Mount Prospect Public Works Department

INTEROFFICE MEMORANDUM

SUBJECT: FNSP – S. WILLIAM STREET – PRELIMINARY PLANS AND TEMPORARY MEASURES
PUBLIC OUTREACH SUMMARY

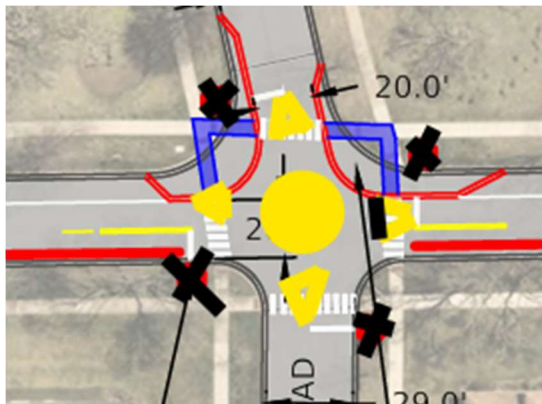
While the current proposal for the intersection is an improvement, I believe that a roundabout here would better improve traffic calming. The current proposal already has traces of a roundabout within it, as the two yellow striped sections can act as splitter islands. Below, I have crudely mocked up a drawing in MS paint to demonstrate my idea.

Sunset Road/William Street Intersection

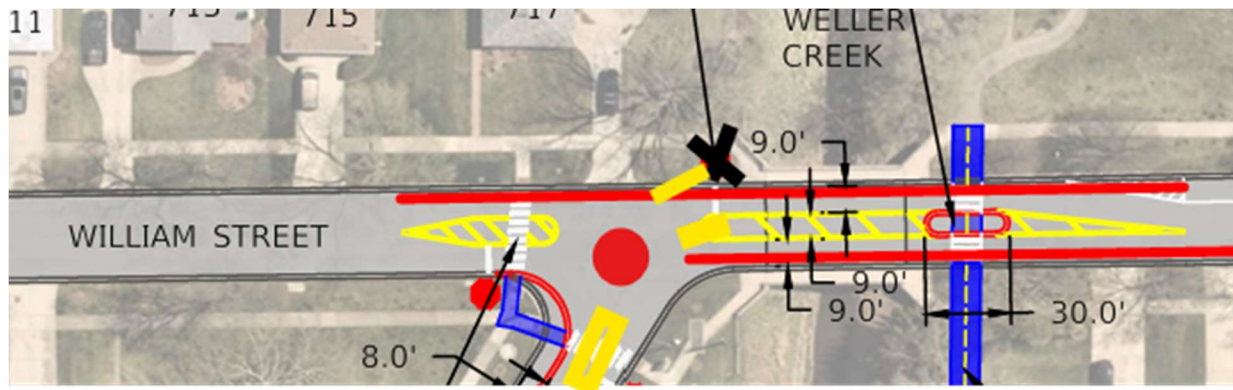
Similarly, I propose a small roundabout here, as there should be ample space for one. Again, I have mocked up a drawing for reference.
